## 工程指示 / 要求簡箋(E.I.)

工程指示編號：EI / 8154 / 24 修改版次：-  
 工程編號：J - 858 工程名稱：將軍澳日出康城 11  
 工程項目：(特色層) 後裝窗 鋁料 玻璃線和鋁角 (5 隻窗 驗樓用) 地盆用  
 收件人：生統 發件人：Ant Yeung 日期：08/08/2024

JOB NO. : J-B58  
 PROJECT : PROPOSED RESIDENTIAL DEVELOPMENT AT TKOIL 70RP, PHASE 11, LOHAS PARK TSEUNG KWAN O, N.T.  
 TITLE : IN-SITU ALUM. WINDOW ALUM. WINDOW SCHEDULE AT SPECIAL UNITS FLOOR  
 DRAWN BY :  
 CHECKED BY :  
 DATE : 04-OCT-21  
 SCALE : 1:40  
 DWG NO. : J058-W-2103b  
 REV. : C

Description: 6mm玻璃线

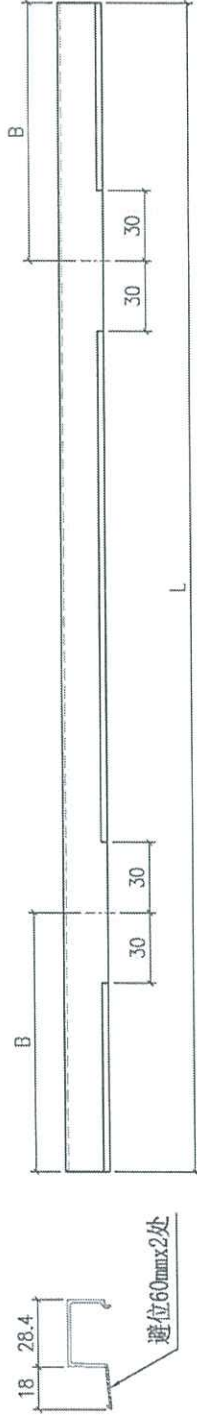
T1	BB	L = 143.5	X 2	L = 846	X 1
T2	BB	L = 143.5	X 2	L = 636	X 1
T3	BB	L = 143.5	X 2	L = 761	X 1
T2	AF	L = 218.5	X 2	L = 636	X 1
T3	AF	L = 218.5	X 2	L = 761	X 1

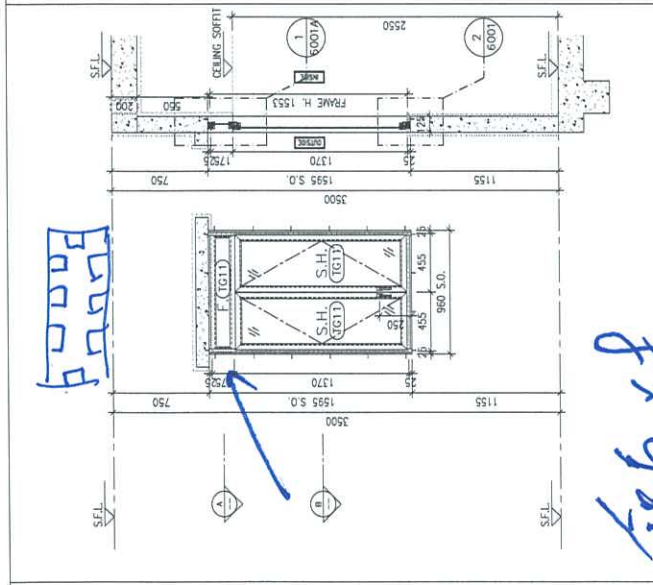
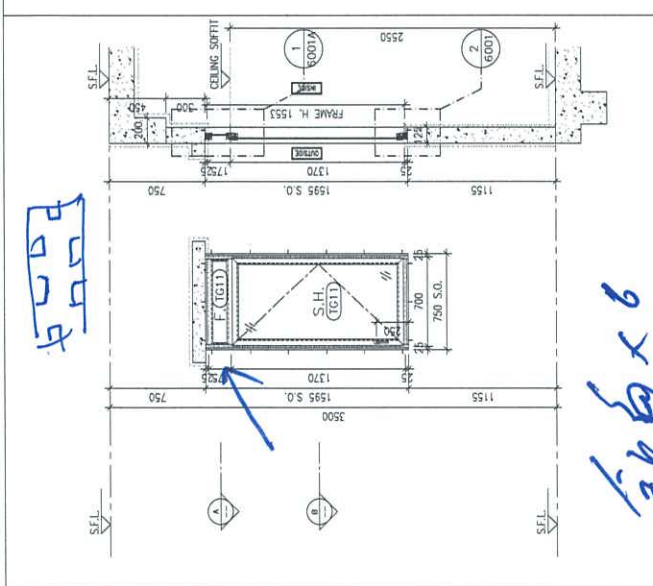
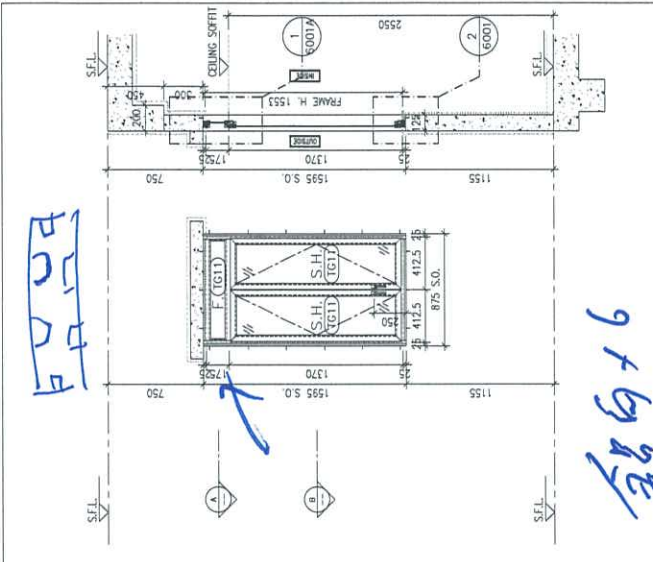
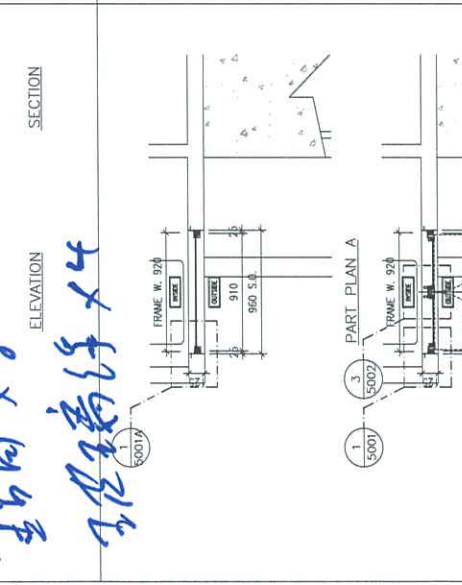
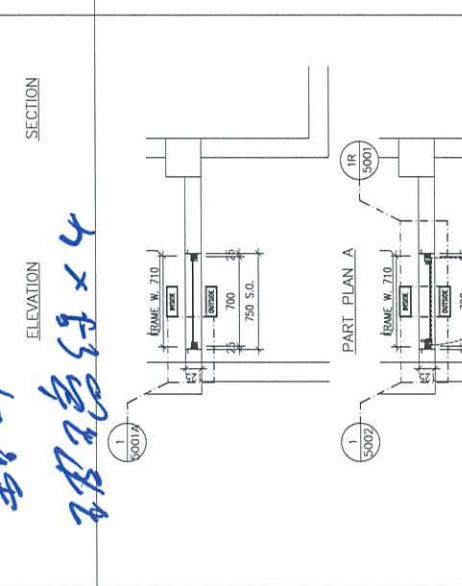
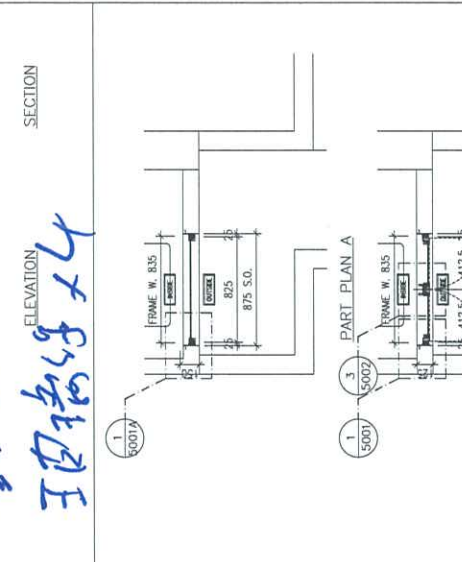
5 隻窗，驗樓用按則師要求，BD Sir 度尺 5 隻窗，見光不足。T1, T2, T3 BB (Kit) BB/K-1 窗見光不足，將拆除百葉玉。改裝玻璃。T2, T3 AF (Kit) AF/K-1 窗見光足，將拆除百葉玉。改裝玻璃。合共改動 5 隻窗，驗樓用請生產玻璃線和鋁角，送地盆供改裝玻璃用。分窗包扎，合共五扎。出貨前請拍照。謝謝請在 2024.08.13 前完成上列要求。

T1 T2 T3 BB (Kit ) BB/K-1 窗見光 Glazing Area 不足，將拆除百葉玉。改裝玻璃。

T2 T3 AF (Kit ) AF/K-1 窗見光 Glazing Area 不足，將拆除百葉玉。改裝玻璃。

- □9/F flat roof AB, AC, AD, AF, AG, BF not yet complete and cannot be measured.?  
Require remeasurement at OP inspection
- 67/F BA, BB living room sliding door not yet install and cannot measure the glazing area.  
Require remeasurement at OP inspection
- □67/F AF, AA, BA, BB kitchen glazing area is less than "required" stated in GBP. ?Please review with OSR on the rectification / replacement of window.
- □9/F, 10/F flat BD bathroom window glazing is less than "required" stated in GBP. All

合共改動5隻窗，驗樓用

上述改述改動為批圖生產後，現場改動。稍後另外附上報價。
